Subject: Little Cedar Creek Rehab
Project Modification
IOAP Project No. S_CC_CC_67997_M_01_C
Civil Action No. 3:05-cv-236-S
DOJ Case No. 90-5-1-1-08254

MSD is requesting approval of a proposed minor project modification to the Little Cedar Creek Interceptor project (IOAP Project No. S_CC_CC_67997_M_01_C). This request is part of the ongoing adaptive management review of the Integrated Overflow Abatement Plan (IOAP), approved May 2021.

Little Cedar Creek Interceptor Minor Modification Request
November 16, 2022
Page 3

Attachment A: 2021 IOAP Modification Fact Sheet (Updated)

Figure 1

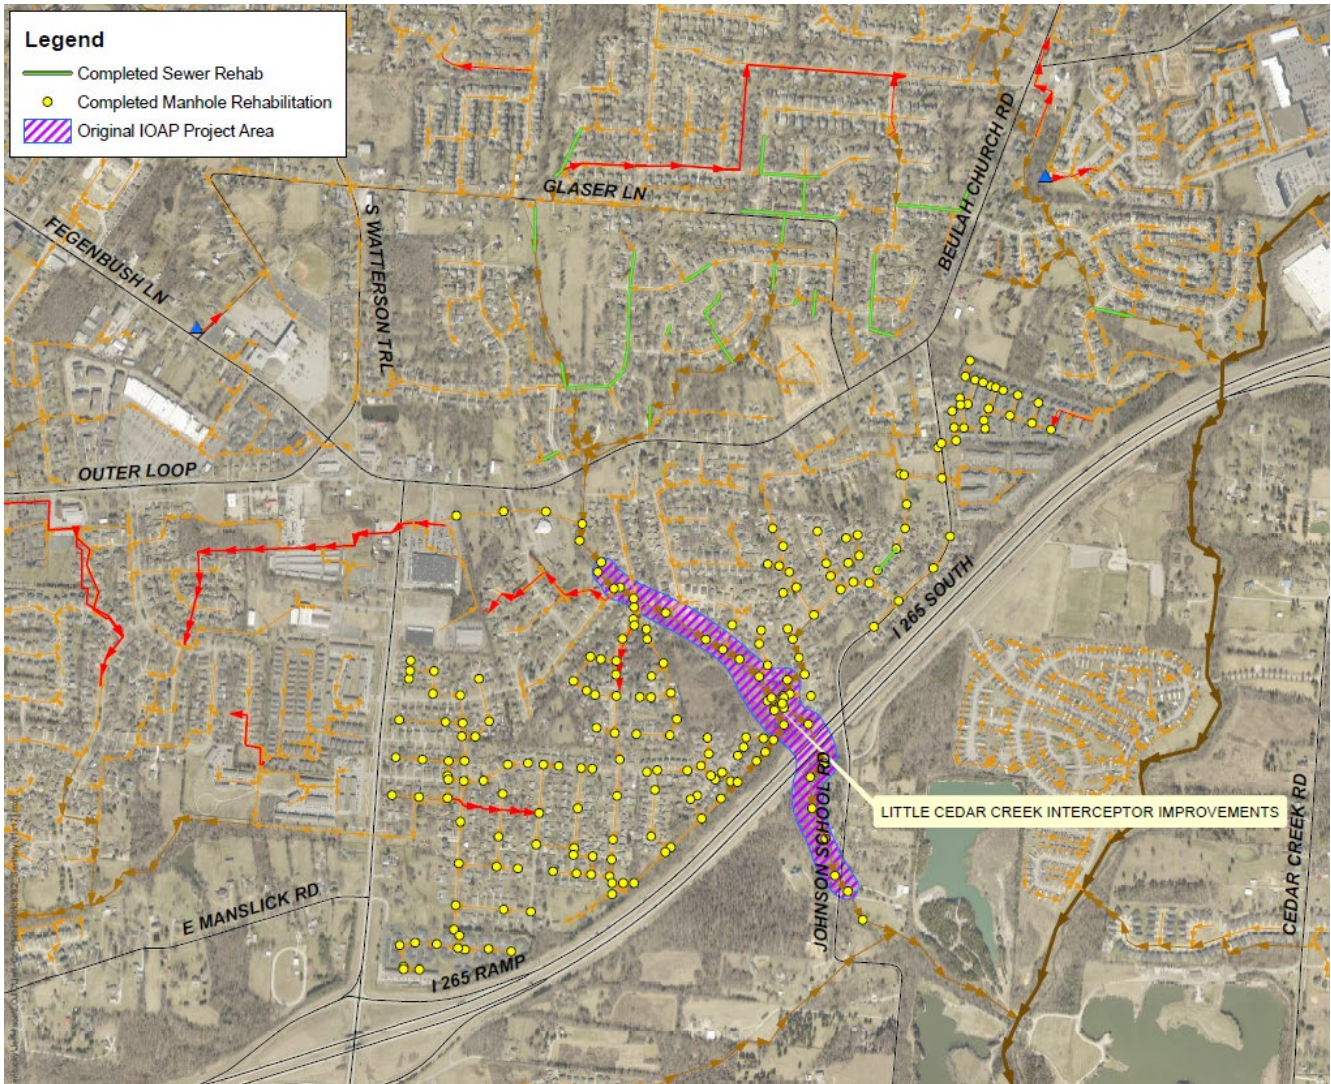
The project modification request involves eliminating the proposed project. MSD performed successful sewer rehabilitation upstream of the project area in 2013, recalibrated modeling indicates that no overflows occur for a 2-year cloudburst event, and no overflows have been documented since 2015.

After the 2009 IOAP was approved, as part of the Capacity, Management, Operation, and Maintenance (CMOM) Program, MSD performed a Sanitary Sewer Evaluation Survey (SSES) inspection in the collection system upstream of the SSO location and detected significant defects in the system needing repair. In 2012 and 2013, MSD performed rehabilitation based on these results. The rehabilitation project consisted of epoxy coating or chimney seal replacements in 212 manholes, raising 3 manhole rims, and cured-in-place pipe lining for 43 pipe segments totaling 8,575 LF in length. Figure 1 shows where the system repairs were made relative to the proposed project location.

In 2020, MSD installed flow monitors in the area to review and update the calibration of the existing models. Four discrete rainfall events, each with a rainfall depth between 1.5" and 2", occurred during the flow monitoring period and were used for analysis. Initial model simulations using the pre-rehabilitation model parameters significantly overpredicted peak flow rates and volumes when compared to the observed data, and the model parameters were re-calibrated using those four events. After re-calibration, 2, 5, and 10-year events were simulated, and the models predicted no overflows for a 2-year cloudburst event. Additionally, overflow records from 2014 through 2021 were reviewed. During that period, one event, April 3, 2015, created an observed overflow. This rainfall event had a total depth of 2.9", greatly exceeding the 2-year cloudburst rainfall depth. There were no other observed overflows during the reviewed duration. Therefore, the updated model calibration and a review of historical overflow data since the rehabilitation was completed demonstrate the rehabilitation successfully mitigates the solution to a 2-year level of control. Therefore, no further mitigation is justified and no project is necessary.

Little Cedar Creek Interceptor Improvements

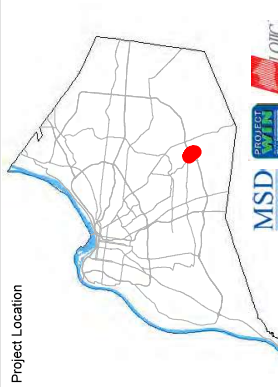
Project Description This alternative includes upsizing 3,701 LF of open cut sewer and 215 LF of 21" tunneling interceptor pipe in the area to increase hydraulic capacity during wet weather peak flows.

ELIMINATED
